INDESIT company

ARTXF149EU/HA

F061079

Technical Documentation guidelines

1260310 Exploded views

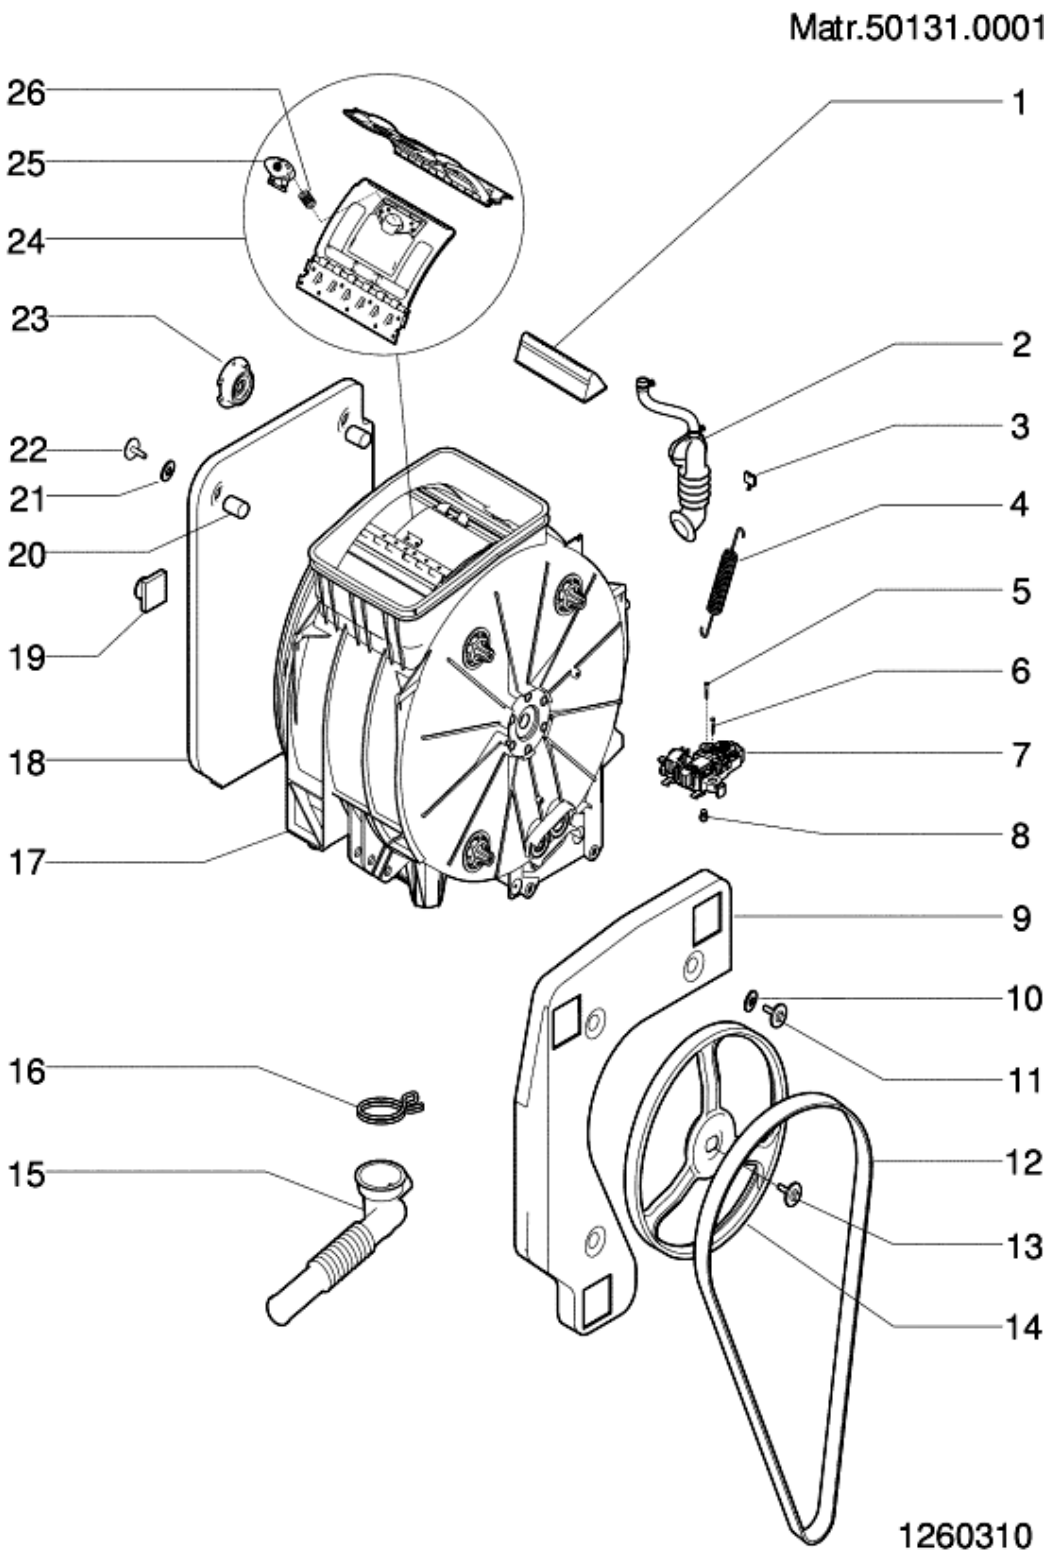
n4009a02: Motor fixing changed on Top Loading washing machines

Top Loading washing machines have changed the fix of motor to the tub.
The tub design is changed in the motor fixing side and two new screws code C00268497 are introduced instead of the old screws C00084333 and the old nut:

C00266015 nut of products with Triphase motor;

C00258673 nut of products with Collector motor.

n4011e13: NEW STEAM EXHAUST HOSE TL INTRODUCED

Spare parts warehouse will go on to manage only the new tubs with the same spare part codes:

C00111505 - Tub 600/1000 rpm

C00111573 - Tub 1200 rpm

C00252343 - Tub 1400 rpm

In assistance on premodification products with the new tubs, you have to fix the motor using the new screws C00268497 instead of the screws and nut that you find in the product.

When the pre-modification items are no longer available, all parts will have to be ordered and replaced.
